# Randwick Local Planning Panel (Public) Meeting

Thursday 22 August 2024

## Development Application Report No. D64/24

**Subject:** 3-7 Lexington Place, Maroubra (DA/346/2024)

**Figure 9:** Markup of GFA plans – additional areas shaded orange (*Source: Orosi Architecture*)

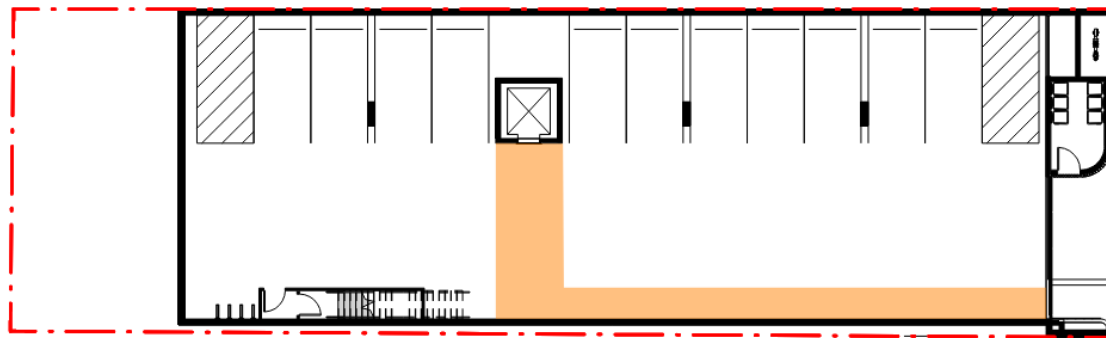
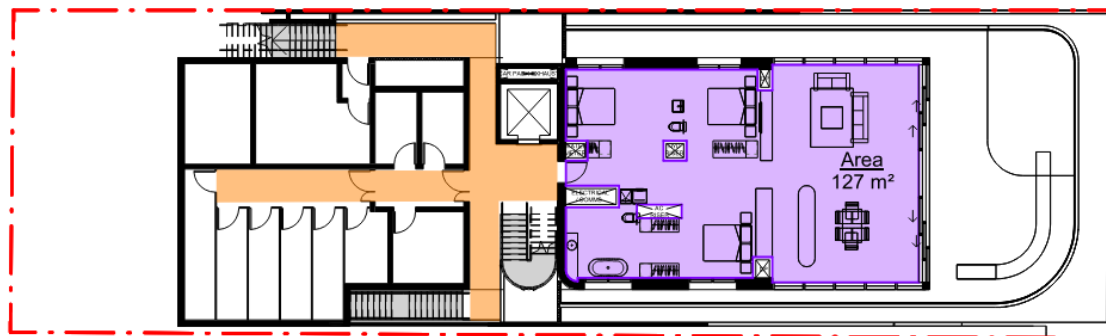
The submitted documentation has incorrectly calculated the GFA (and resultant FSR) of the proposed development, as follows (refer Figure 9):

**Figure 10:** Existing and proposed view from 3/111 Arden St courtyard (Source: Orosi Architecture)

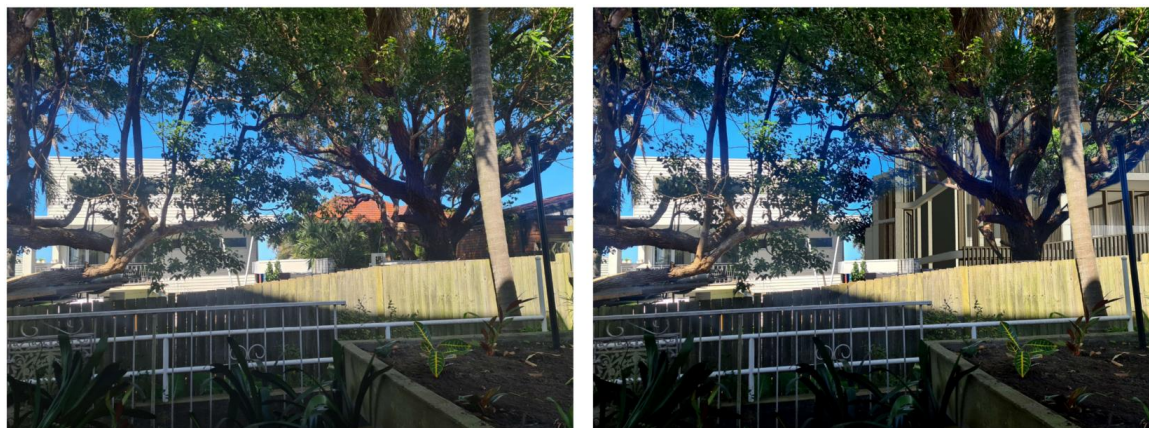
- 3/111 Arden Street – as shown in Figure 10, the proposal is likely to result in a minor loss of sky views. These views are partially obstructed by existing vegetation.
- 9/111 Arden Street – as shown in Figure 11, the proposal is likely to result in a minor loss of sky views. These views are partially obstructed by existing vegetation.

**Figure 11:** Existing and proposed view from 9/111 Arden St balcony (Source: Orosi Architecture)

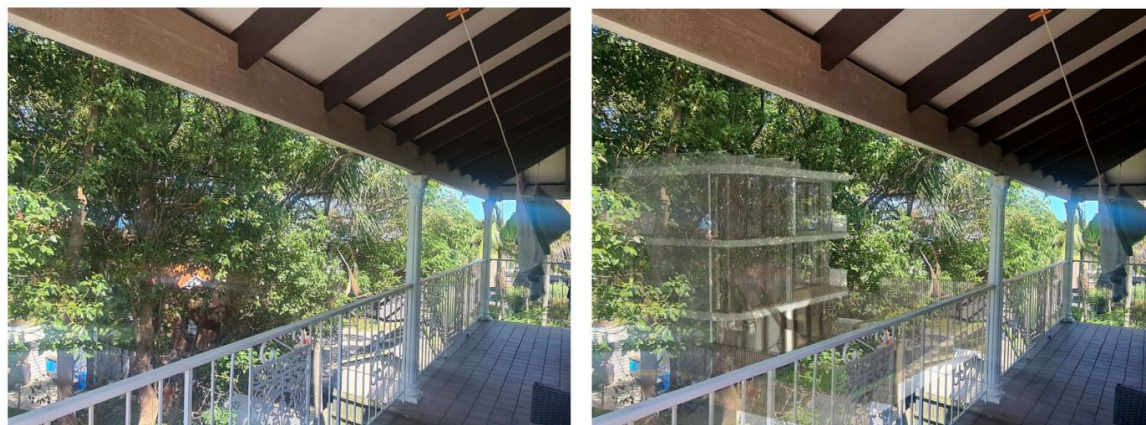
- 117 Arden Street – as shown in Figure 12, the proposal is likely to result in a minor loss of views of the ocean and horizon.
- 370 Alison Road – as shown in Figure 13, the proposal is likely to result in a minor loss of district views. Views of the ocean, horizon, and land-water interface will be retained.
- 66 Beach Street – as shown in Figure 14, the proposal is likely to result in a severe loss of views of the Coogee headland (land-water interface) and Gordons Bay. Views of the ocean and horizon will be retained.
